**STATE OF NEW HAMPSHIRE  
INTER-DEPARTMENT COMMUNICATION**

**SUBJECT:** Dredge & Fill Application  
Wakefield, M312-13  
**Response to RFMI /Amendment 1  
(DES#2019-03386)**

**WETLANDS PERMIT APPLICATION  
REQUEST FOR MORE INFORMATION**

**Re: Wetlands Permit Application (RSA 482-A); NHDES File Number: 2019-03386**  
**Subject Property: NH Route 153, Wakefield**

REVISED WETLAND IMPACT PLANS  
 DATE 12-17-2019

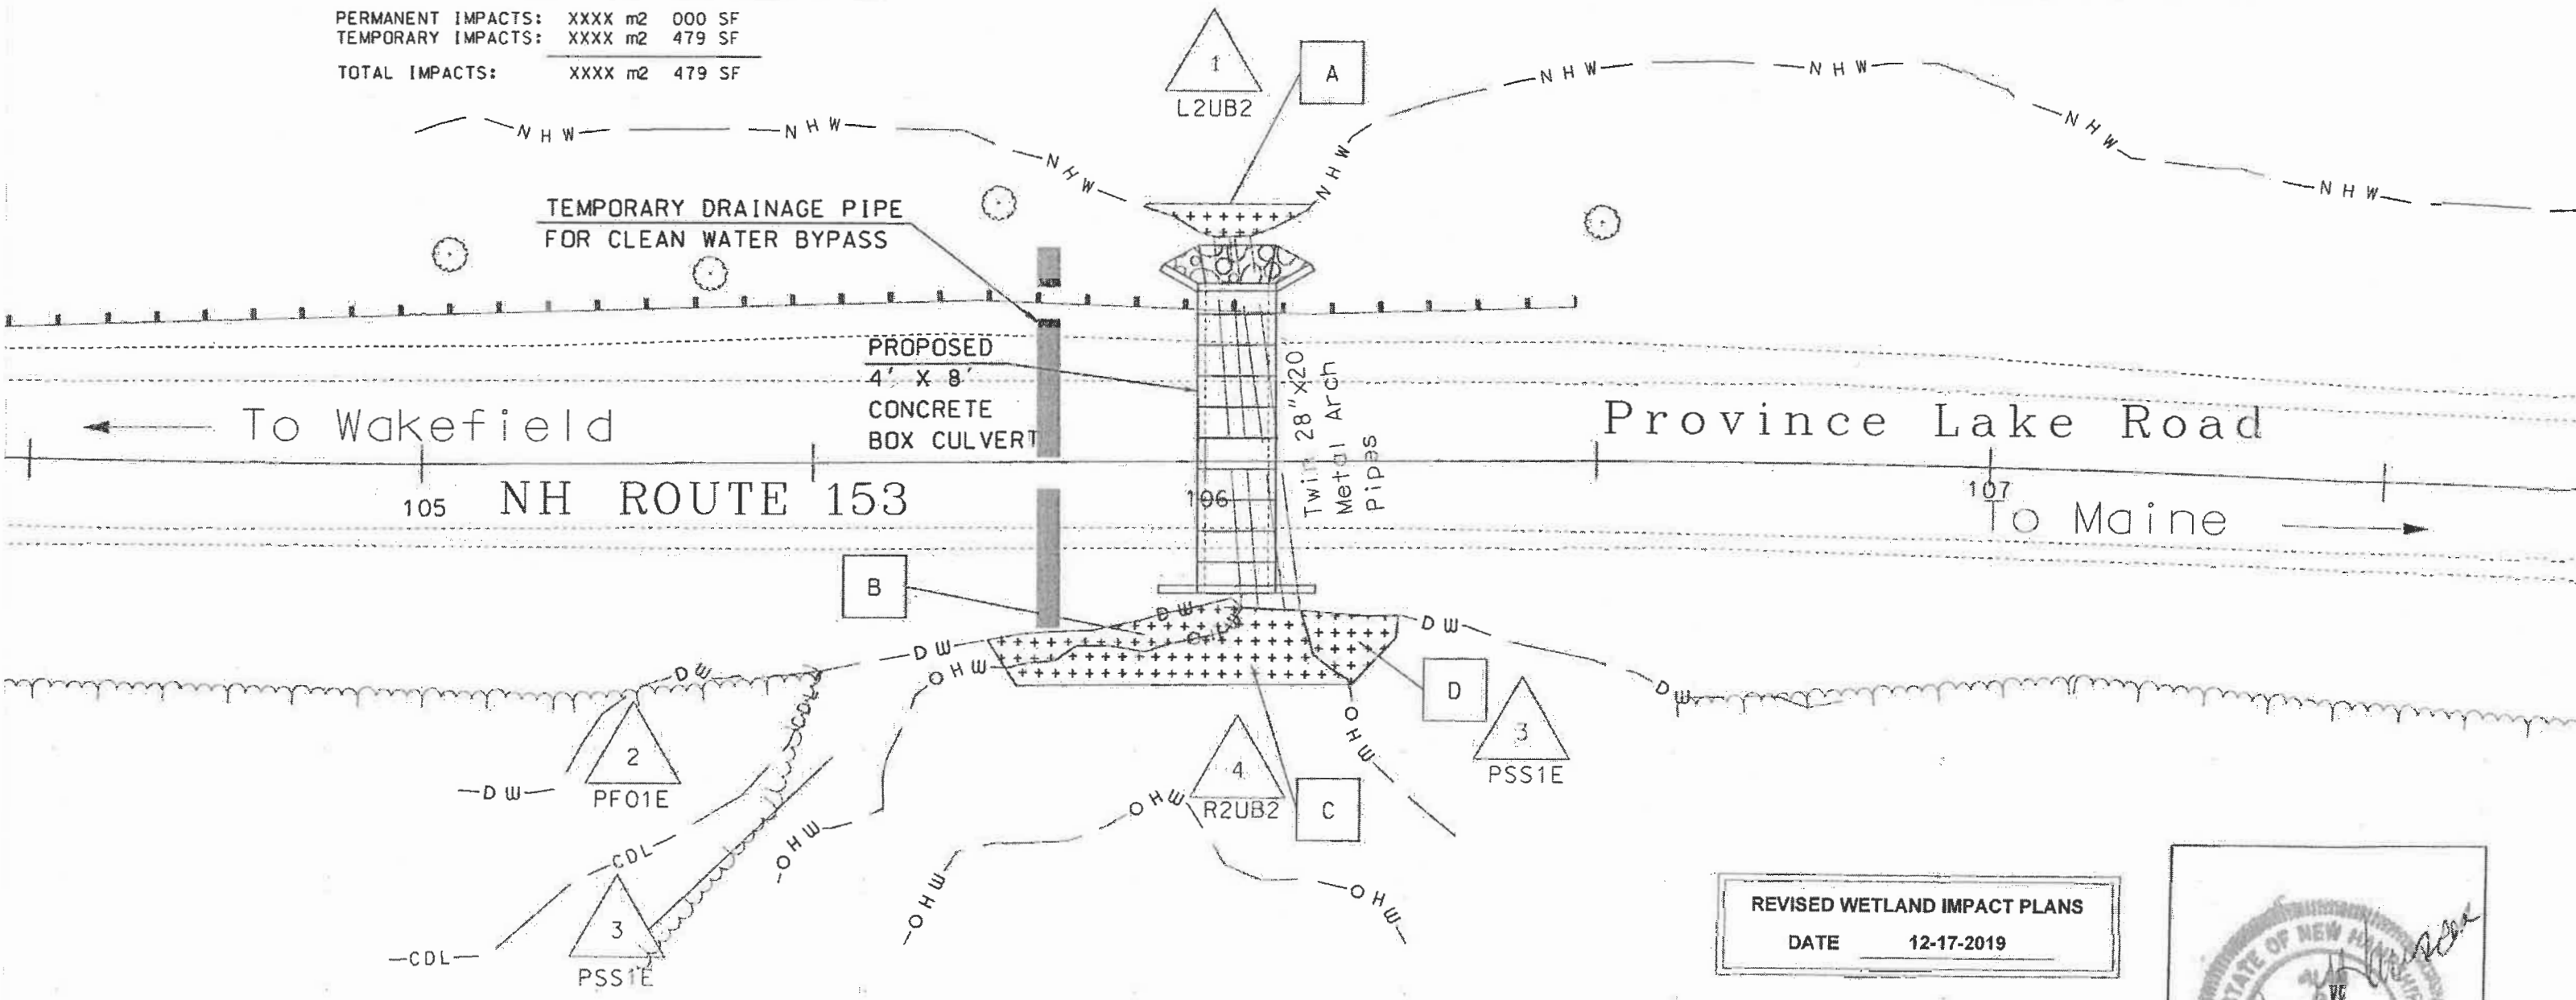
3. **Plan Requirements:**
  - a. In accordance with New Hampshire Administrative Rule Env-Wt 904.04(g) and Env-Wt 303.04(l), plans drawn for a new or replacement Tier 3 stream crossing and plans for temporary cofferdams and other water control devices constructed in flowing water shall be stamped by a Professional Engineer (PE) who is licensed under RSA 310-A to practice in New Hampshire. Please provide an updated plan set to include a PE stamp.

- b. In accordance with New Hampshire Administrative Rule Env-Wt 301.01, please revise the plan to include the stamped of the Certified Wetland Scientist who conducted the delineation.

6. Administrative Provisions: In accordance with New Hampshire Administrative Rule Env-Wt 501.02, please revise the plan to depict the boundaries of the right-of-way, the location of the proposed project within the right-of-way, and the location of the properties of abutters with each lot labeled with the abutter's names and mailing addresses. In accordance with RSA 482-A:11 II. and New Hampshire Administrative Rule Env-Wt 502.02(b), if any work associated with the project will encroach outside of the NHDOT's right-of-way, onto abutting property, then please demonstrate right of access / easement from by (1) obtaining temporary construction easements or other written agreements from the owner of the abutting property owner, and (2) submitting a copy of each agreement to the NHDES Wetlands Bureau.

- a. *Please find the attached plan that includes a PE Stamp.*
- b. *The plans were delineated by Sarah Large and Matt Urban. In accordance with RSA 310-A:79 III, employees of the government or the State of NH while engaged within the state in the practice of the profession of soil science or wetland science for the government is exempt from the requirement of holding a CWS. As such, the identification of Sarah and Matt as the wetland delineators meets the States obligation. A CWS stamp will not be provided on these plans.*

6. Administrative Provisions: *In accordance with Env-Wt 501.01 The DOT is exempt from abutter notification for public highway construction. Additionally, the work being conducted is located entirely within what is known as a prescriptive ROW that gives the NHDOT the permanent rights to maintain the roadway and our drainage infrastructure, as such since the work is within our Prescriptive ROW and we do not require any easements or abutter approvals.*

REVISED EROSION CONTROL PLANS  
DATE 12-17-2019

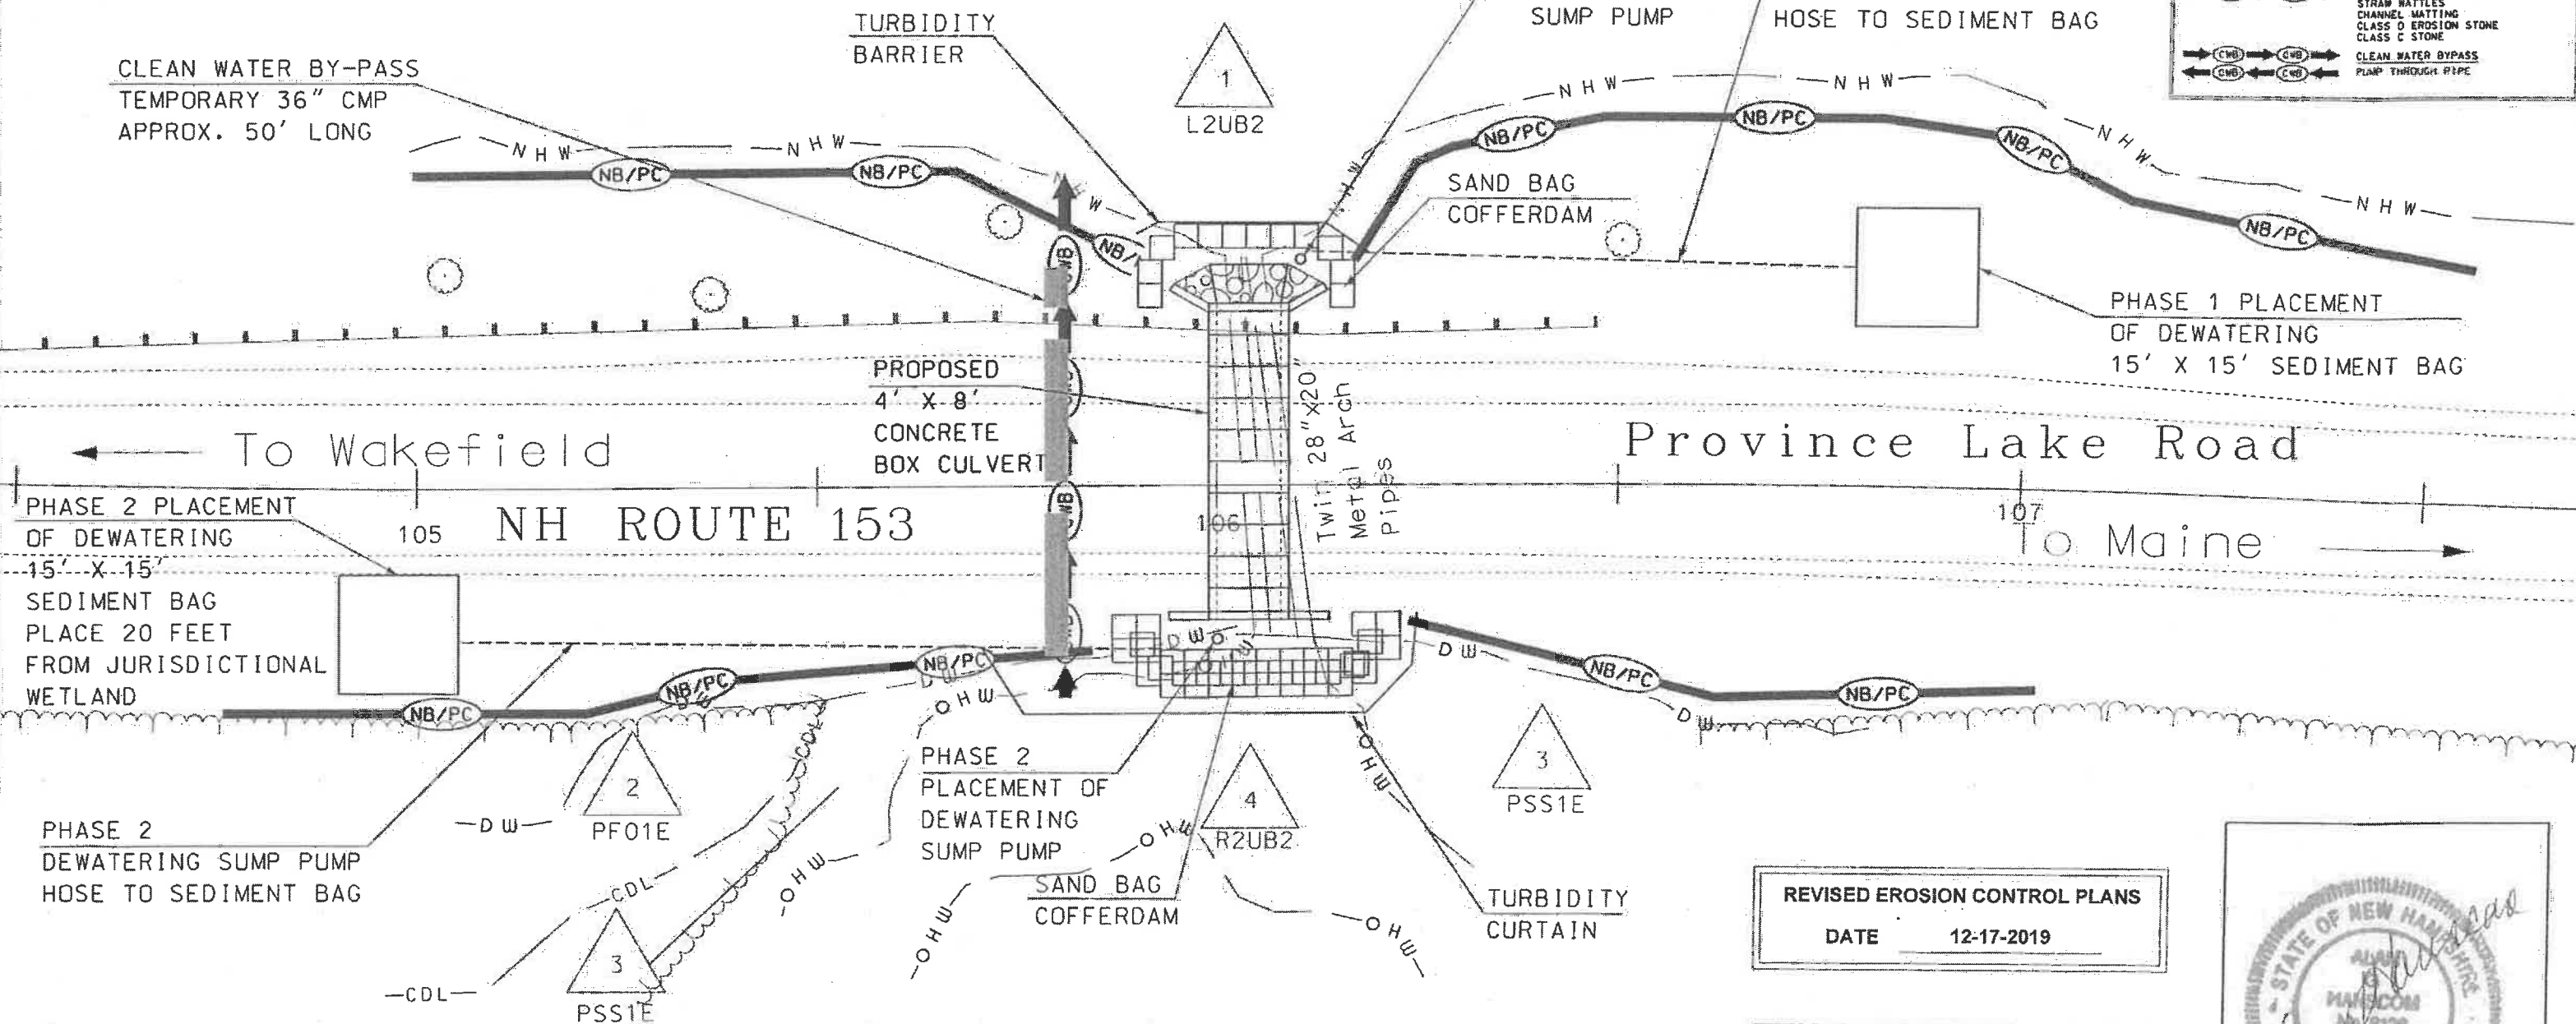
1. **Erosion, Sediment and Turbidity:** In accordance with NH Administrative Rule Env-Wt 501.02, please revise the plan to include more specific proposed methods of erosion, siltation and turbidity controls either indicated graphically and labeled or annotated as necessary. In accordance with NH Administrative Rule Env-Wt 304.06 and Env-Wt 903.03, a coffer dam or turbidity curtain shall be used to enclose dredging projects in and adjacent to marshes, lakes and rivers or along the shoreline of other surface waters. Please provide details regarding the type of erosion, sedimentation and turbidity controls that you are proposing to use.

2. **Diversion / Dewatering:** In accordance with New Hampshire Administrative Rule Env-Wt 903.03(5), please provide a plan which details the proposed diversion and dewatering method including estimated maximum flow to be diverted, the location/height and width of the diversion dam, sump locations and sediment treatment plan with methods and release point. If additional impact areas are required for the stream diversion/dewatering, or adjacent bank stabilization please quantify and include the area on the plan.

Please find the attached plans that have been revised to address erosion, sediment and turbidity in accordance with Env-Wt501.02, Env-Wt 304.06 and Env-Wt-903.03. Traditionally, the Department does not dictate a contractor means or methods and therefore our Erosion Control plans do not always provide a specific details that often are later developed by the Contractor when a SWPPP is prepared. However, since this project is going to be completed by our own District forces we were able to revise the plans to include additional details as requested such as location of the sandbag coffer dam and placement of sediment bags and turbidity curtains.

*Please find the attached plans that have been revised to depict the proposed stream water diversion. Similar to the answer provided above, we typically do not dictate means and methods however, since this project is being completed by District forces we were able to revise the plans to better show the location of the proposed clean water bypass, along with the location, and dimensions of the sand bag cofferdam as depicted in the cross section, along with the sump location, and dewatering locations. In addition to the revisions made on the plans that have been provided the Department has also updated the Construction Sequence with additional narrative support for the proposed Diversion/Dewatering associated with this project.*

**NOTE:**  
COFFERDAMS AND TURBIDITY BARRIER WILL ALSO BE USED TO INSTALL THE TEMPORARY DRAINAGE PIPE.
